TOWN OF HUDSON

PUBLIC MEETING TOWN OF HUDSON, NH OCTOBER 24, 2018

A. Mansfield Drive Subdivision
SB# 05-18

Mansfield Drive Subdivision Conceptual Plan Review Only

PROPOSED ROAD PROFILE - TAX MAP 147/LOT 24
MANSFIELD DRIVE
HUDSON, NEW HAMPSHIRE
 SCALE: HOR: 1" = 40'
 VERT: 1" = 2'
 MARCH 1, 2018
Maynard & Paquette
 Engineering Associates, LLC
 Consulting Engineers and Land Surveyors
 31 Quinoy Street, Nashua, N.H. 03060
 Phone: (603)863-8433 Fax: (603)863-7227

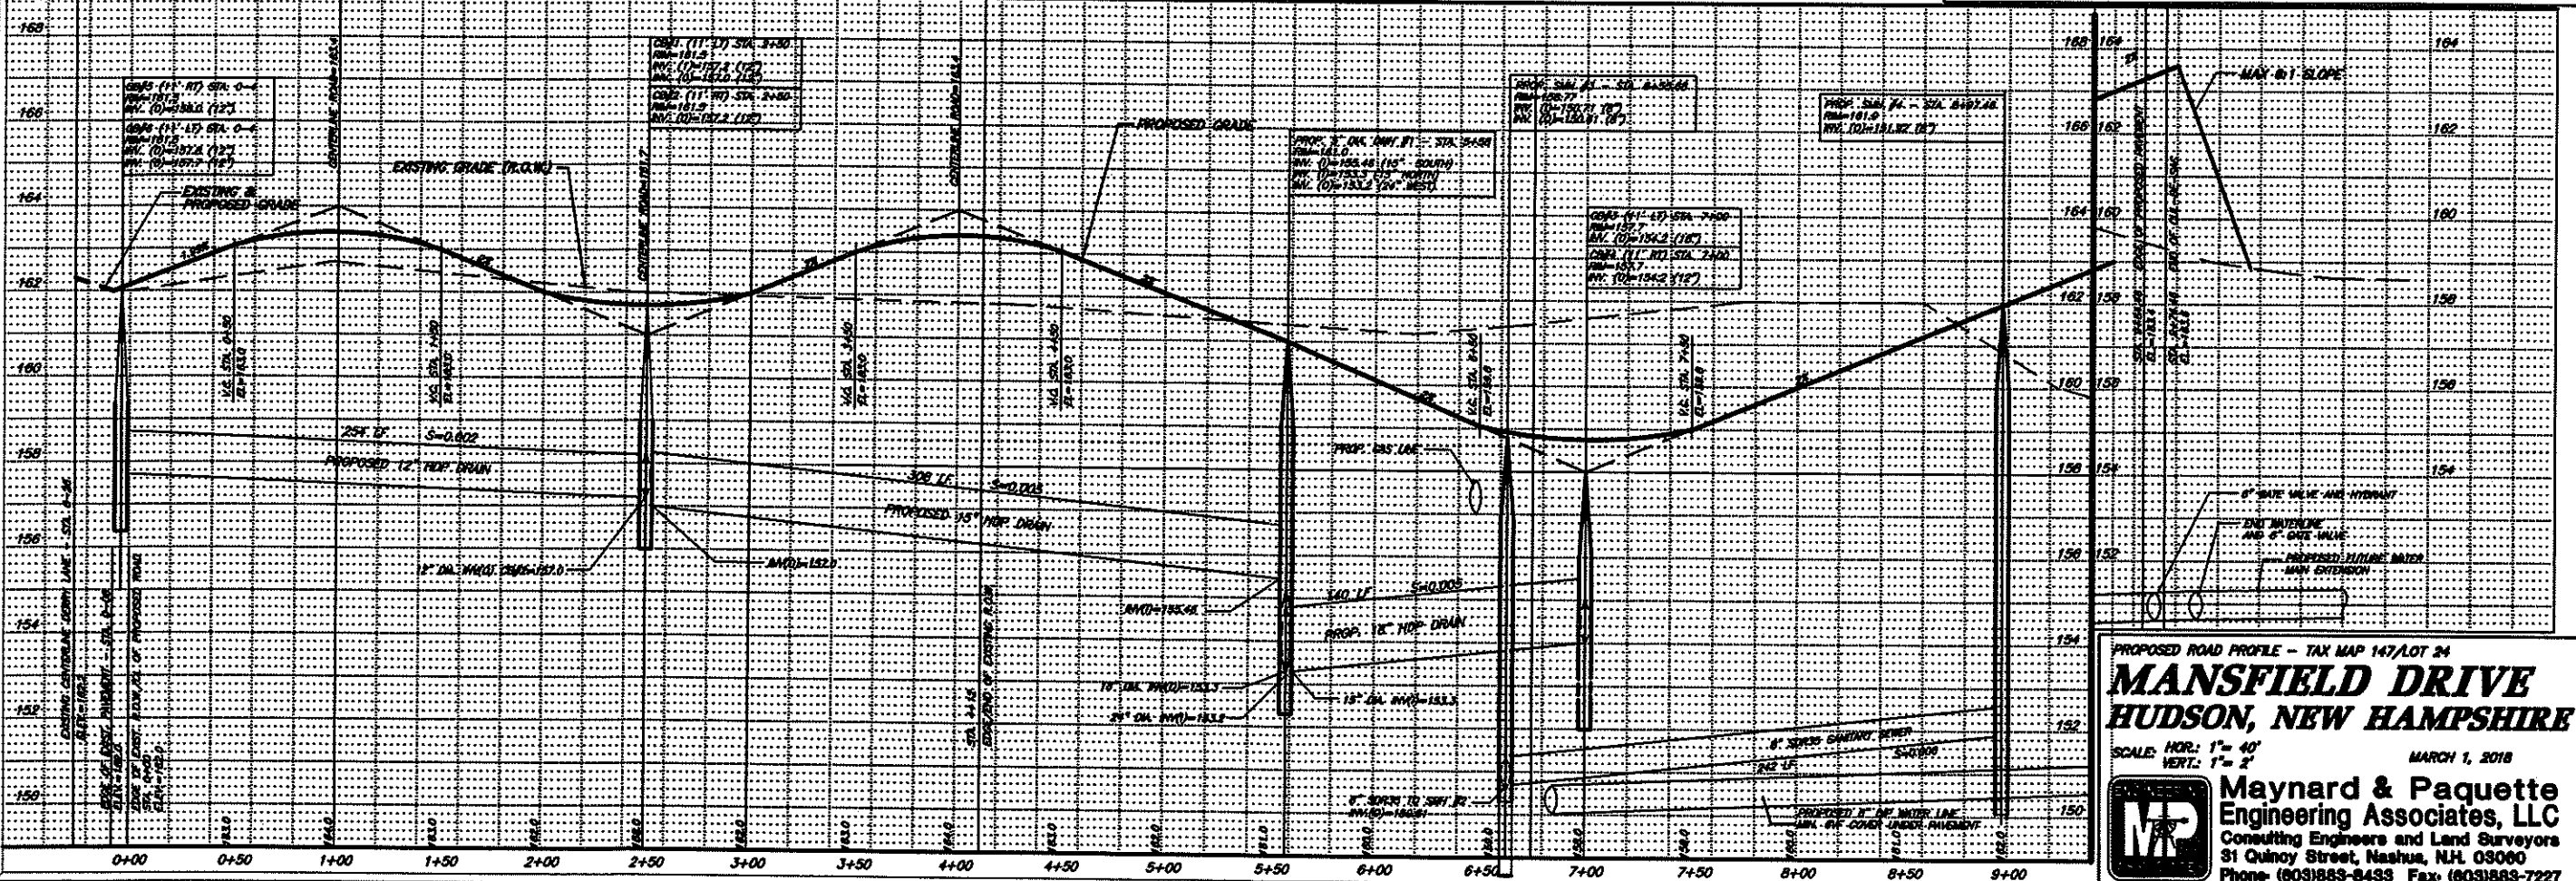
- f. HR 289-18.C.(1). The applicant has not shown center line horizontal curve information on the plan set.
- g. HR 289-18.C.(2). The applicant has not shown vertical curves nor noted their proposed K-values on the plans. (The current plan appears to propose point of vertical angles.)

- l. The applicant has shown on the profile that the Derry Lane centerline elevation and the area of road between the centerline and proposed road will be dropped vertically by over a quarter of a foot, but has not shown any reconstruction details on the plan set.
- m. The applicant should clarify on the plan set, the limits proposed for use of the perforated drain.

3g – vert curves added

PROPOSED SANITARY SEWER - TAX MAP 147/LOT 24
MANSFIELD DRIVE
HUDSON, NEW HAMPSHIRE

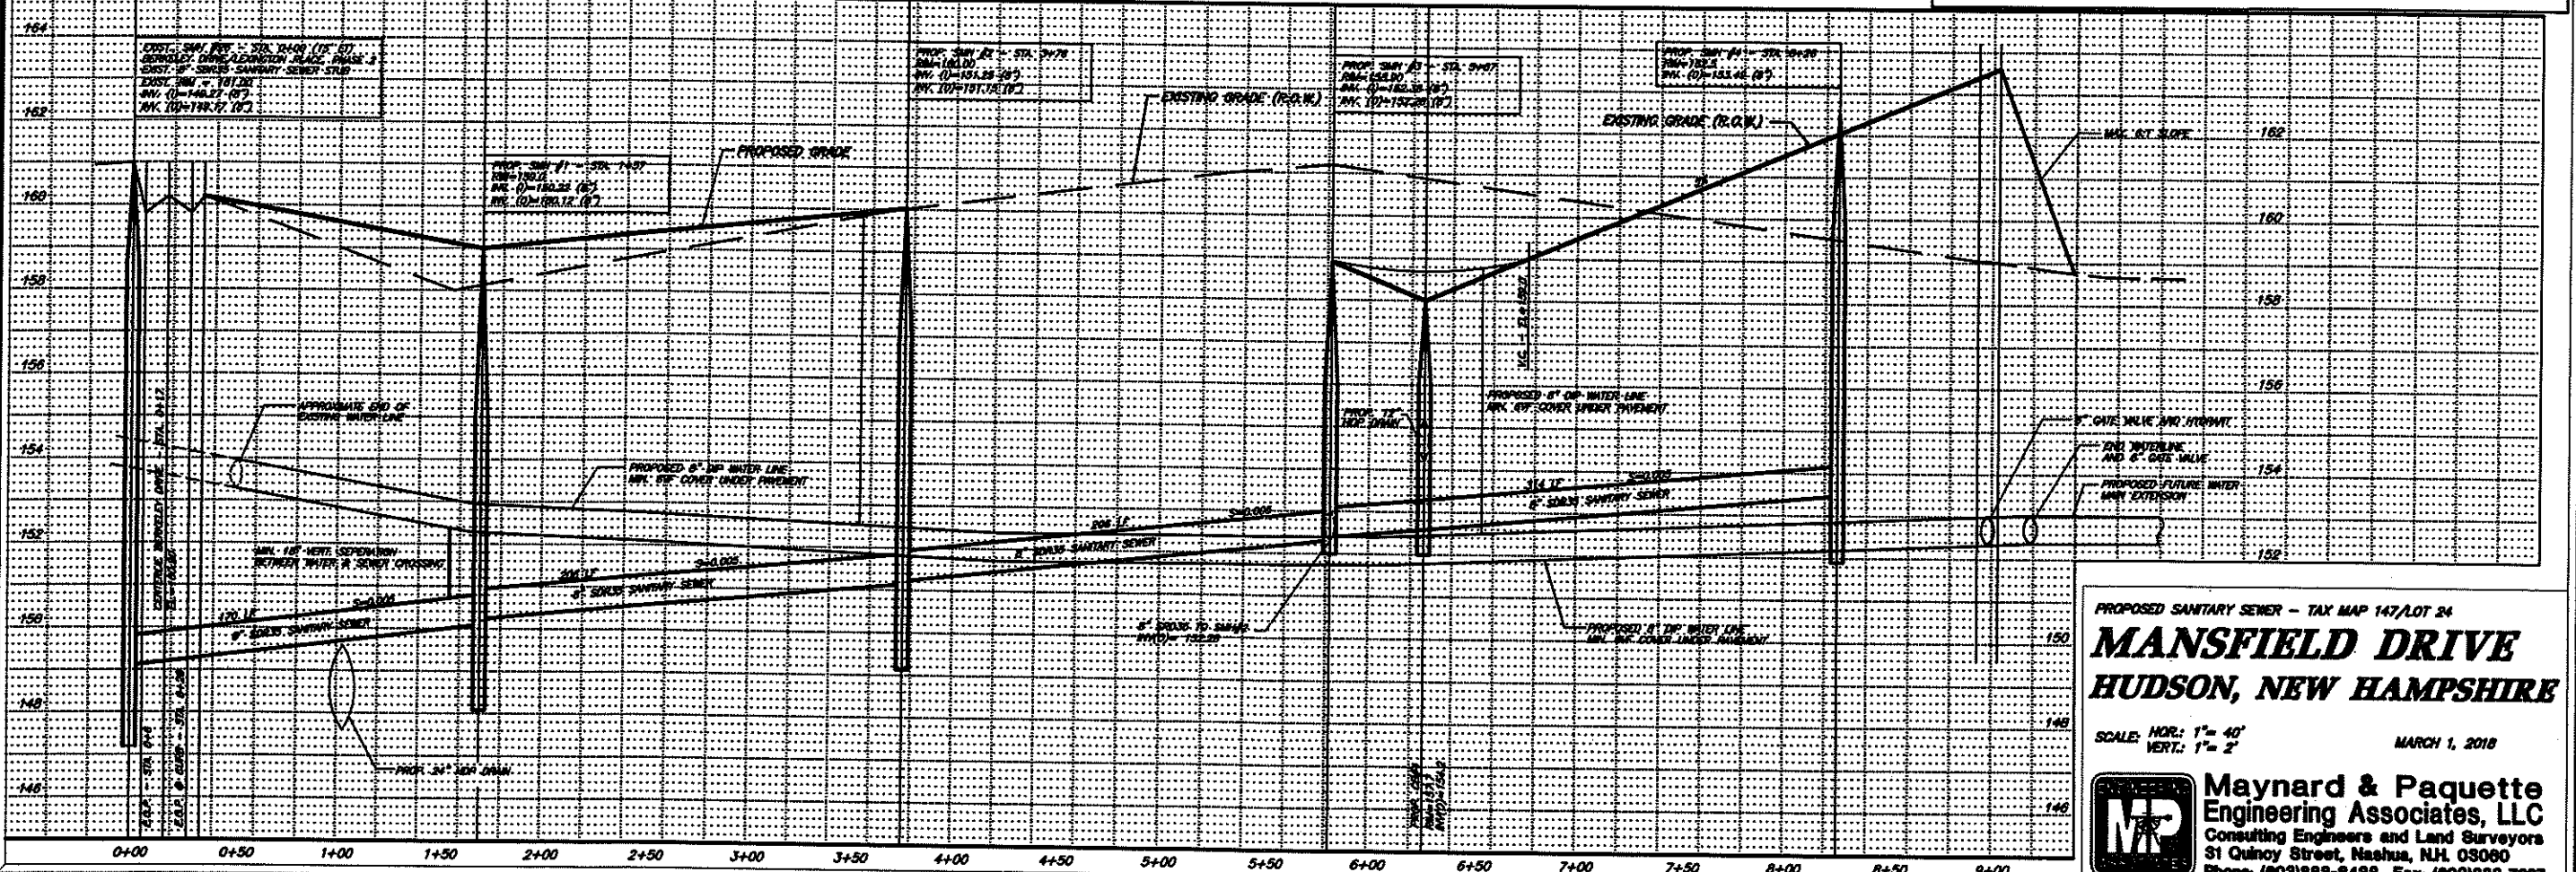
- f. The applicant has proposed a portion of sewer main whose slope is less than the minimum allowed by NHDES Env-Wq-700 (SMH 4 to SMH 3 on sheet 4). This sewer run is also shown on sheet 5 with different inverts and pipe slope. The applicant needs to coordinate the details between plan sheets and provide a pipe slope that meets the minimum required by the Regulation.

ROADWAY CROSS SECTION
N.T.S.

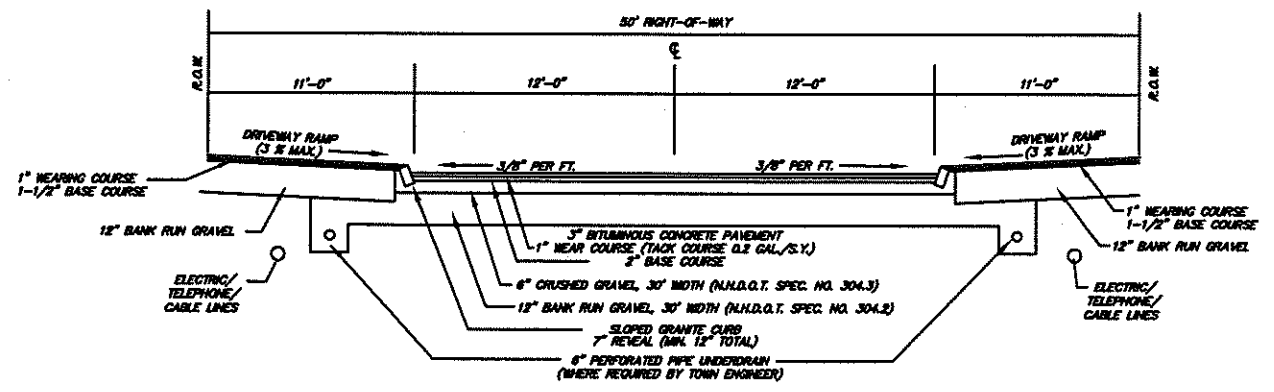
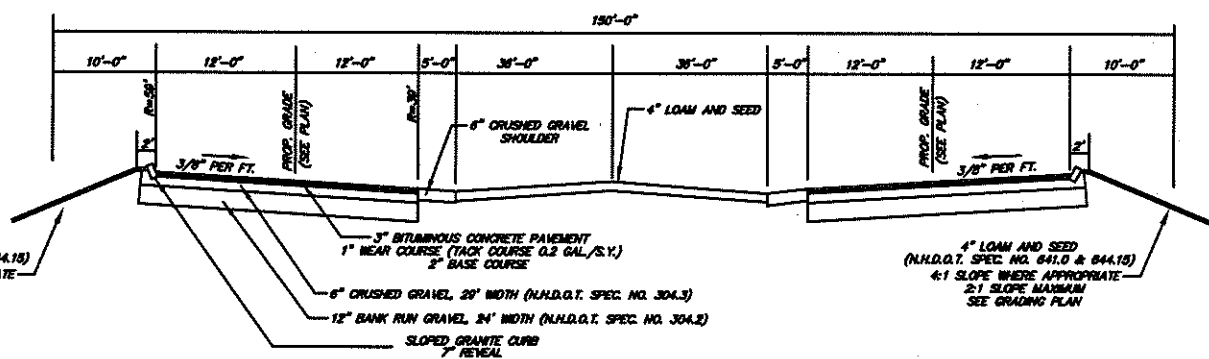
- j. HR 289-28.F. The applicant has provided a curb detail that doesn't match the proposed road cross section (no crushed gravel is shown in the subbase).

3j – see roadway x-section detail

STOP SIGN DETAIL

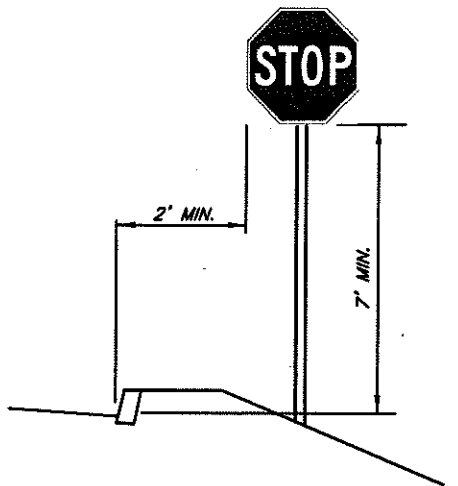
- g. HR 276-11.1.B.(13) and 289-18.O. The applicant has not proposed any signs and has not provided the sign approval note on the plan set. At a minimum, the applicant needs to provide a street name sign at the intersection of Mansfield Drive and Derry Lane, along with appropriate sign details on the plans. Also, the applicant should review the need for a stop sign at the Derry Lane intersection.

1g – street sign and stop sign locations and note added to plans

1. PROVIDE STANDARD TOWN STREET SIGN (MANSFIELD DRIVE) AND STOP SIGN AT INTERSECTION

FIELD STONE MASONRY & CONCRETE HEADWALL

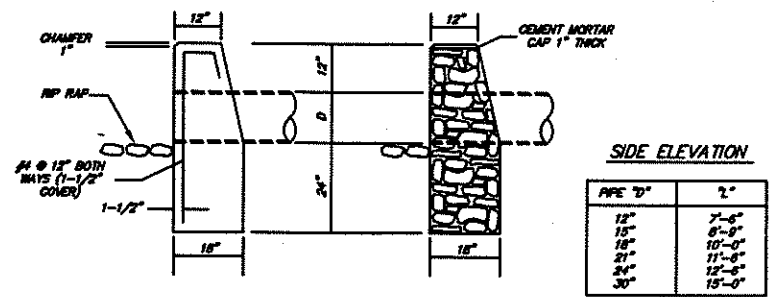
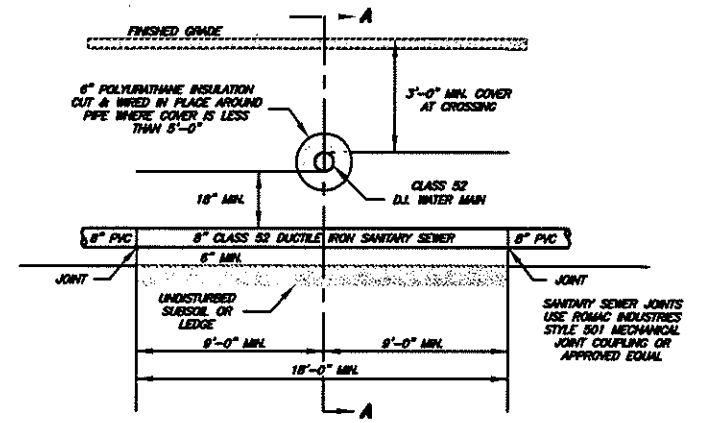
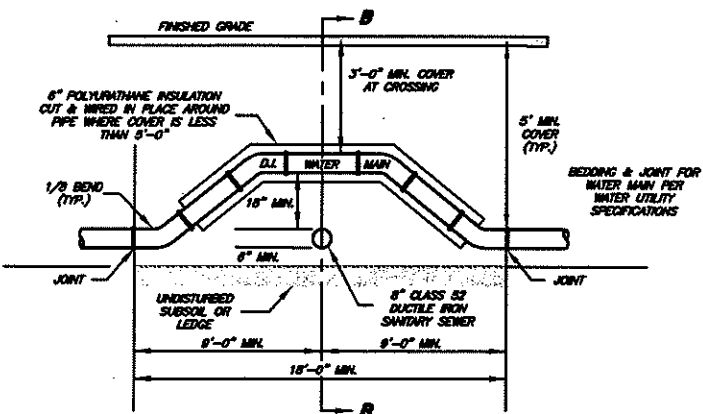
- e. The applicant did not provide a detail for the proposed headwall.
- f. Although the applicant has shown a six foot deep stormwater basin, the street invert is only 3.3 feet above the bottom of the basin. Without calculations, we are unable to determine how far into the pipe the water is likely to remain.

6e – details added
